SERVICE BULLETIN

CHECKING AND REPLACEMENT OF STATOR ASSY.

SB-912-026

SB-914-014

Bild / Fig. 1

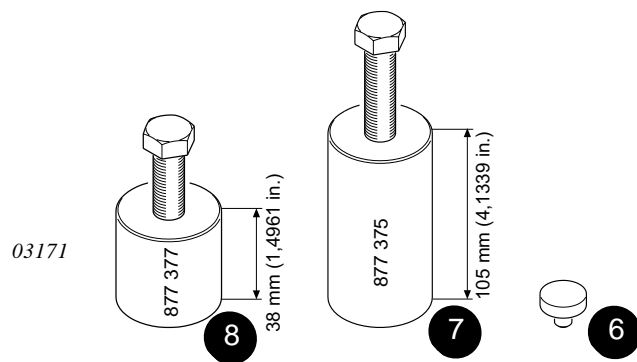
See fig. 1 und 5.

- Remove hex. screw M16x1,5 x 40 (16) together with lock washer (17) and washer (18).
- Apply some grease on protection piece (part no. 877.417) and place it onto the crankshaft, screw puller (part no. 877.375)(7) or screw puller (part no. 877.377) (8) fully home on thread (19) and pull off flywheel assy. (20).
- Lay flywheel assy. aside so that no particles can collect on the magnets.

Bild / Fig. 2

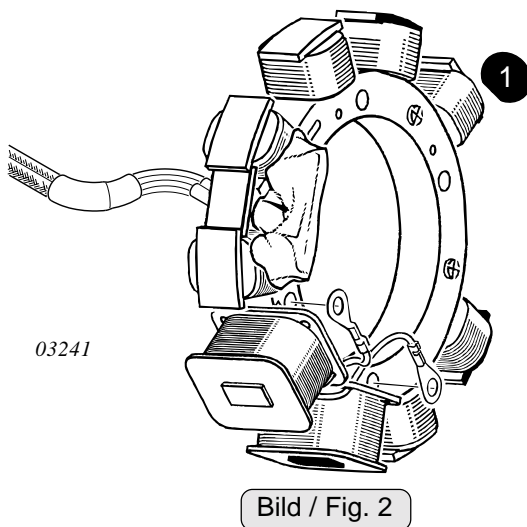
See fig. 2 and 5.

- Check all cable connectors, all ground connections, charging and shorting cables and grounding cables for tight fit, good contact, corrosion and security, repair as required.

- Verify shielding of cable assemblies for damage, for ground contact and security.

- Inspect all 8 ignition cables to spark plug connector for damage and tight fit. Check resistor plug connector for tight fit on spark plug. Repair or replace as necessary.

Bild / Fig. 3

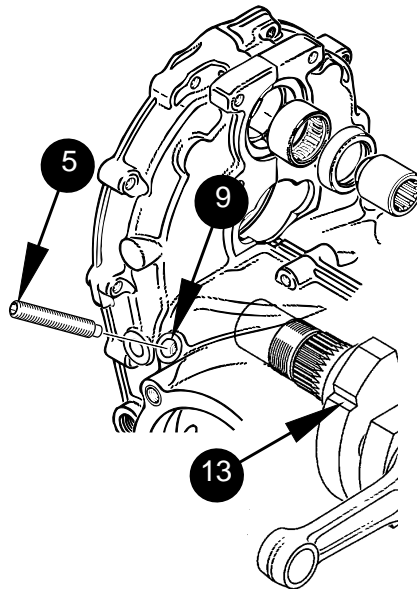
See fig. 3 and 4.

- To lock the crankshaft remove the plug screw (1) M8x20 and sealing ring from the crankcase half (cyl. 2/4) (9). Turn crankshaft until the pistons of cyl. no. 1 and no. 2 are in T.D.C. and lock crankshaft in this position with the crankshaft locking screw (5) (part no. 240.880).

- Turn-in crankshaft locking screw and rotate crankshaft slightly to-and-fro until the screw engages noticeably in the recess (13) of the crankshaft and tighten locking screw to 10 Nm (90 in.lb).

- Remove crankshaft locking screw (part no. 240 880)
- Install the plug screw M8x20 and new gasket (part no. 950 141) on crankcase half (2/4). Tightening torque 22 Nm (195 in.lb.).
- Check or adjust the air gap of the external triggers with feeler gauge to dimension ① .

View: new stator
Fig.: 5

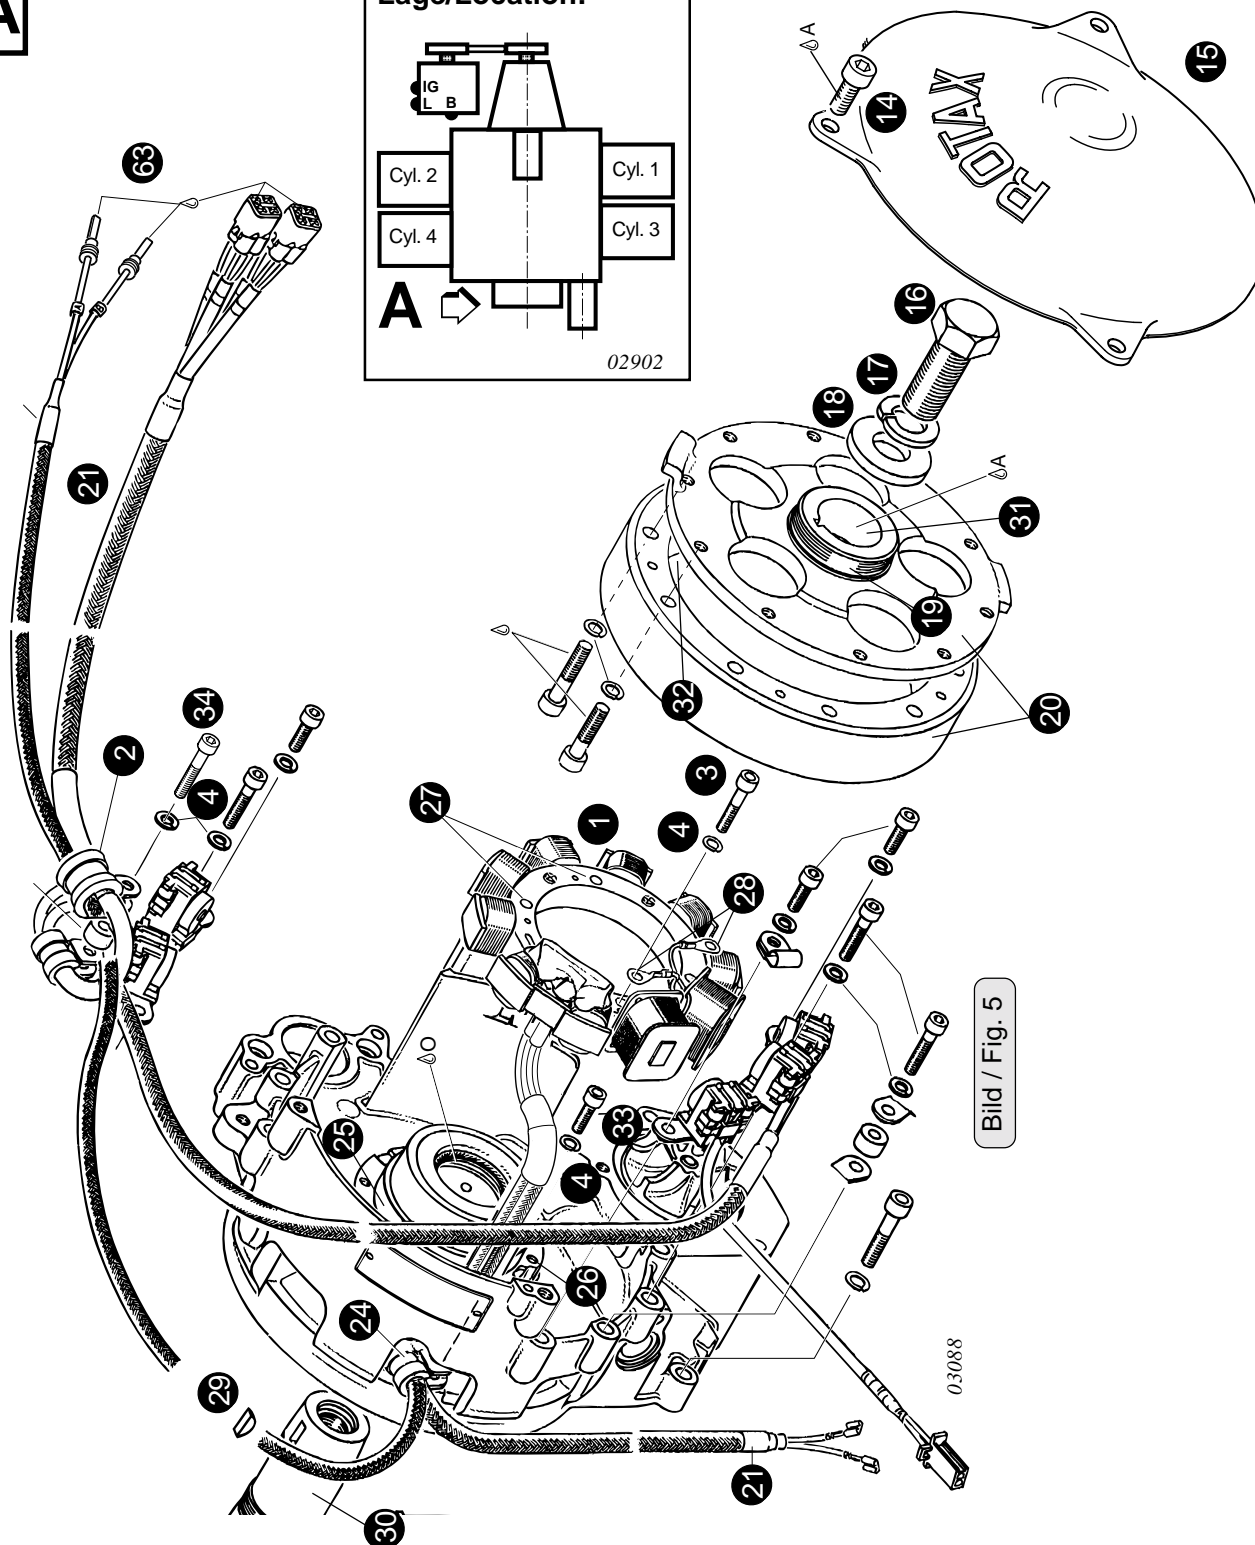
- Remove the 4 Allen screws M5x25 (3) along with lock washer.
- **Group A/B and E:** To detach the cable harness (21) remove the Allen screw (33) M5x16 and Allen screw (34) M5x30 along with lock washer. Remove the cable clamp (part no. 851.110) (24) and cable clamp (part no. 851.250) (2). Mark the plug connections (63) for convenience at reassembly, disconnect plug and detach plastic clamps (62) and cable clamp (64).

- **Group C and D:** To detach the cable harness (21) and grounding cable (72) remove the Allen screw (22) M5x20 and Allen screw (35) M6x30 along with lock washer. Remove both cable clamps (part no. 851.110) (24). Open the screening box (49) and mark the plug (50) of charging cable for convenience at reassembly and disconnect the plug. Detach clip plate and remove the cable harness from the clip plate (51).

- Remove the stator ass'y (1) from the centering (25) of the ignition housing.

- At installation apply Lithium grease to the contact faces (27) of the stator and the screw heads.
- Install stator ass'y on the centering of ignition housing. Fit the 4 Allen screws (3) M5x25 and tighten to 6 Nm (53 in.lb).

- **ATTENTION:** One each charging coil grounding cable (28) has to be connected with stator attachment screw.
- **Group A/B and E:** To install the cable harness (21) fit the cable clamp (part no. 851.250) (24) with Allen screw (33) M5x16 and cable clamp (part no. 851.250) (2) with Allen screw (34) M5x30 and lock washer. Attach cable harness with cable clamp (64). Re-establish plug connection corresponding with marking. Secure with plastic clamps.

- **Group C and D:** Attach grounding cables (72) with Allen screw (35) M6x30 and lock washer. To attach the cable harness (21) use the cable clamp (part no. 851.250) (24) and Allen screw (33). Fit cable harness on clip plate (51) and attach. Reconnect plug (50) corresponding to marking. Close the screening box (49), secure cables with new plastic clamps.

Bild / Fig. 4

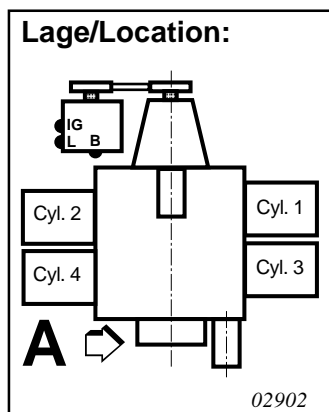
- For easy location finding of the correct crankshaft position, turn crankshaft so that the impressed 4-digit number (10) on the flywheel hub (11) aligns with the edge (12) of the ignition housing.

- The required crankshaft recess position (13) can be additionally verified with a flashlight through the hole in the crankcase (9).

Bild / Fig. 6

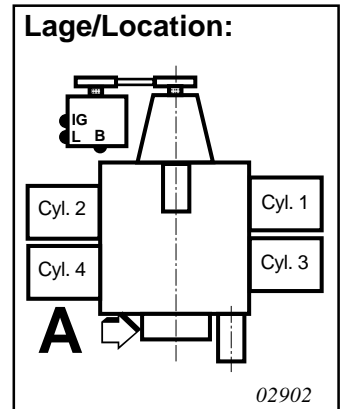
- Inspect magneto inner side (32) for any foreign particles and the taper surface (31). Under normal circumstances it is not necessary to take the flywheel apart.
- Check Woodruff key (29) in crankshaft for tight fit and degrease taper of crankshaft (30) and flywheel hub (31). Apply LOCTITE 221 sparingly, but well spread into the taper of magneto hub.
- Fit flywheel hub ass'y, washer 17/36/5 (18), lock washer (17) and hex. screw M16x1,5 x 40 (16) and tighten to 120 Nm (1060 in.lb).

Maße/Dimensions	Neu/New	Verschleißgrenze/Wear limit
Geberspalt für "alte" Geber gap for "old type" trigger coil	0,4 ÷ 0,5 mm (0,016 ÷ 0,020 in.)	0,5 mm (0,020 in.)
Geberspalt für Geber mit Klammern gap for trigger coil with clamps	0,3 ÷ 0,4 mm (0,012 , 0,016 in.)	0,4 mm (0,016 in.)

Bild / Fig. 7

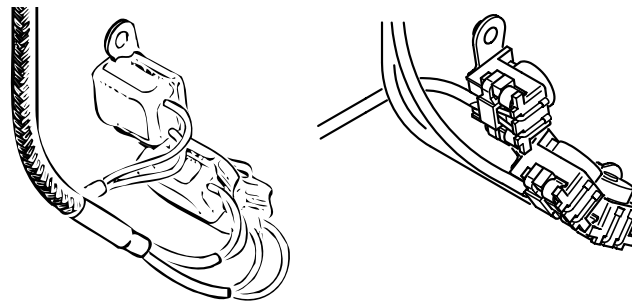
▲ **WARNING:** Make sure that the Woodruff key remains in the keyway. A loose or a loss of Woodruff key can create failures including no-starting or advanced ignition timing.

Bild / Fig. 8

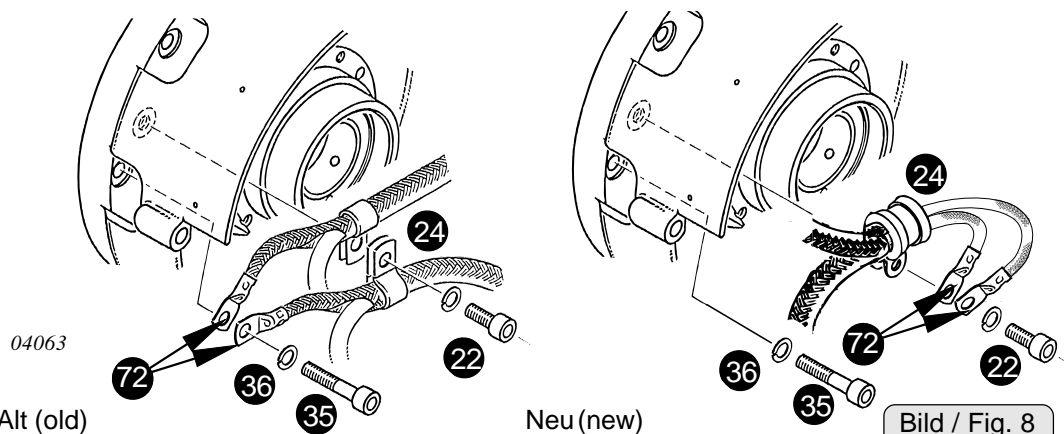
- Carry out a visual inspection on the contact surface on the stator charging coils grounding cable for deposits of sealing and transparent insulation compound to warrant a proper seat and electric contact of the stator and ground cable. Remove any deposits carefully as required with a suitable tool e.g. spot miller (73).

- Carry out a visual inspection on the eyelet connectors of the charging coils grounding cable on both sides for deposits of sealing and transparent insulation compound. Remove any deposits carefully, without applying any tension on the cables with a suitable tool e.g. scraper.

- ▲ **WARNING:** At the installation of the stator ensure proper grounding of the grounding cables (eyelet connector) via the screw head/thread to the ignition housing. Also ensure proper contact of the fixation screw to the ignition housing, which is achieved by careful examination and cleaning of all contact surfaces. Failures to do so may result in engine failures or stoppage.
